Memorandum

To: Town of Washington Zoning Board of Appeals
From: Aaron Werner, AICP
Date: January 12, 2024 – **Updated February 15, 2024**
Re: 324-346 Fowler Rd
cc: Heather Croner & Catherine MacKay Croner (property owners)
Douglas E Larson (Larson Architecture Works, PLLC) (Applicant)
Alicia Moore (AKRF, Inc.)
Kyle Barnett; Meghan Clemente (ZBA Attorney)
Jonathan Ialongo (Town Building Inspector)

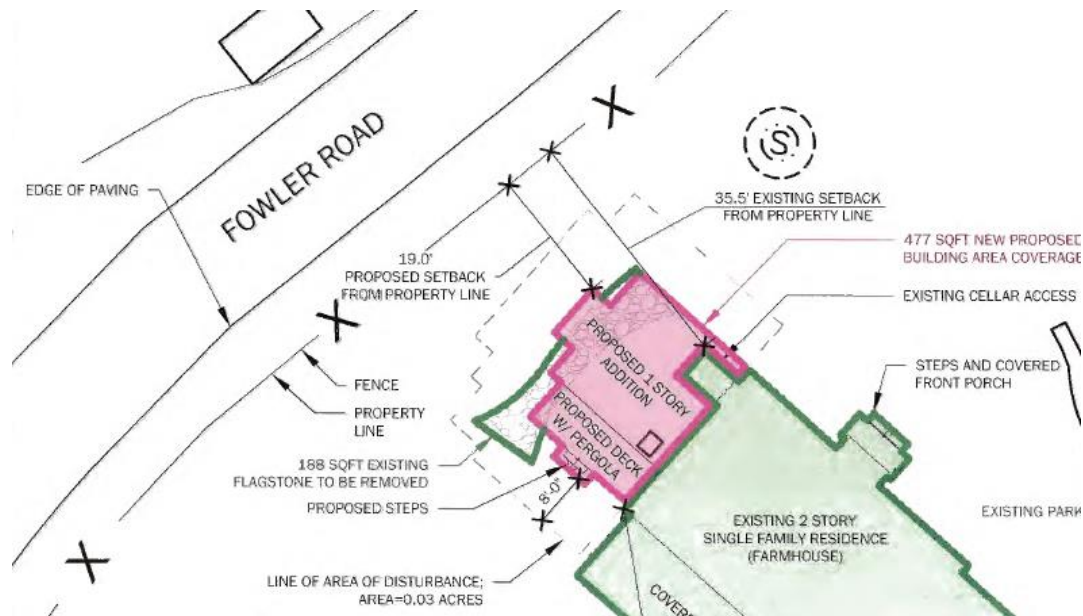
8. 11/19/23: The existing house is preexisting nonconforming, as the front setback from Fowler Road is 45 feet, where 100 feet is required. The proposed addition would extend from the western end of the house, decreasing the setback to 26.5 feet. An area variance for this additional 18.5 feet of encroachment is required.

2/15/24: At the November 21, 2023 meeting, the ZBA directed the Applicant to measure the existing/proposed front setback from the property line and not the street line. The Applicant updated both the existing and proposed setbacks as directed. The existing setback to the property line is 35.5 feet and the proposed setback with the addition is 19 feet. Based on the resubmission

dated December 21, 2023, the Applicant is requesting an area variance for the additional 16.5 feet of encroachment. See image below.
